Access Compliance Report

Public Rights-of-Way

(Curb Ramps)

Intersection ID: 46725	Main Street: FAWN_VIEW_DR	Cross Street: HAMILTON_FOREST_DR	Location:	N
ADA ID: 565CF805FB5C	Ramp Type: PerpDiag	Initial Pass/Fail: Fail	Overall Compliance: No	Severity Score: 21.25
Codes/Mitigation Info/Possible Solution		Field Measurements/Component Compliance

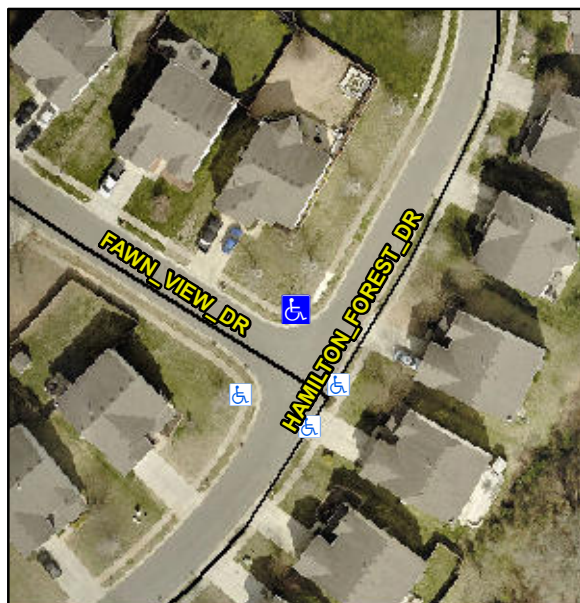
Not Found, R304.5.1, R304.2.2

Compliance	Description	Data	Compliance	Description	Data
N/A	Ramp Length (in)	47.0	No	Ramp Slope (%)	9.5
No	Ramp Width (in)	38.5	Yes	Ramp XSlope (%)	1.8
N/A	Flare Type LT	N/A	N/A	Flare Type RT	N/A
N/A	Flare Slope LT (%)	N/A	N/A	Flare Slope RT (%)	N/A
N/A	Flare Traversable LT?	N/A	N/A	Flare Traversable RT?	N/A
N/A	Landing Length (in)	N/A	N/A	DWS Provided?	N/A
N/A	Landing Width (in)	N/A	N/A	DWS Contrast?	N/A
N/A	Landing Slope (%)	N/A	N/A	DWS Length (in)	N/A
N/A	Landing X Slope (%)	N/A	N/A	DWS Full Width?	N/A
N/A	Landing Curb? (Y/N)	N/A	N/A	DWS Offset (in)	N/A
N/A	Shared Landing?	N/A			
N/A	Gutter Ponding?	N/A	N/A	Gutter Slope (%)	N/A
N/A	Gutter Lip Ht (in)	N/A	N/A	Gutter X Slope (%)	N/A
N/A	Painted X Walk1?	No	N/A	Painted X Walk2?	No
	X Walk 1 Direction	To SW		X Walk 2 Direction	To SE
N/A	X Walk 1 Width (in)	N/A	N/A	X Walk 2 Width (in)	N/A
	X Walk 1 Slope (%)	3.6		X Walk 2 Slope (%)	1.4
	X Walk 1 X Slope (%)	0.1		X Walk 2 X Slope (%)	2.3

Remove & Replace Curb Ramp With Two New Directional Ramps or Equivalent.
